The reasons for requesting the WM upgrades: Comparison the 20years population growth model with the proposed Development (Blue) vs the Current scenario model (Green)

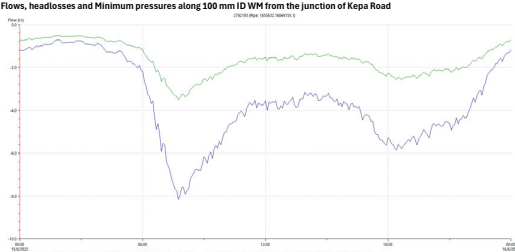
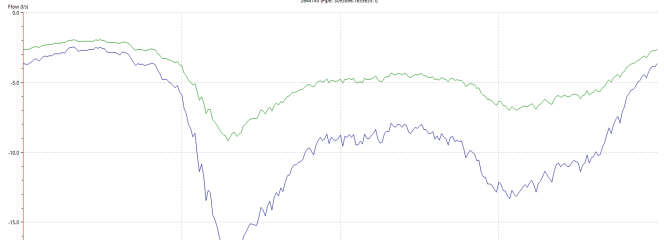
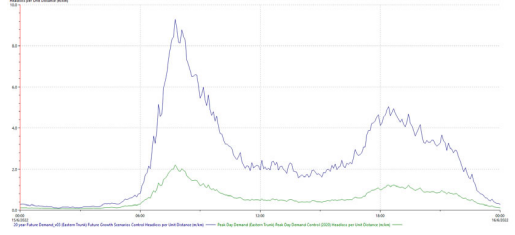
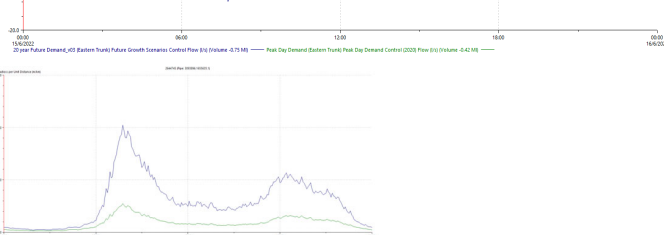
No.	Description	Comparison of WM upgrades requested locations for 20 years future model vs the Current scenario model	
1	200 mm ID WM upgrade is requested about 293 m length along the Kupe street	<p data-bbox="529 217 548 228">Flow</p>  <p data-bbox="667 233 1052 245">Flows, headlosses and Minimum pressures along 100 mm ID WM from the junction of Kepa Road</p>	 <p data-bbox="1215 233 1713 245">Flows, headlosses and Minimum pressures along 150 mm ID WM of the other side of the road from the junction of Kepa Road</p>
		<p data-bbox="529 495 653 506">Maximum unit headloss m/km</p> 	
		<p data-bbox="529 755 611 766">Minimum Pressure</p>
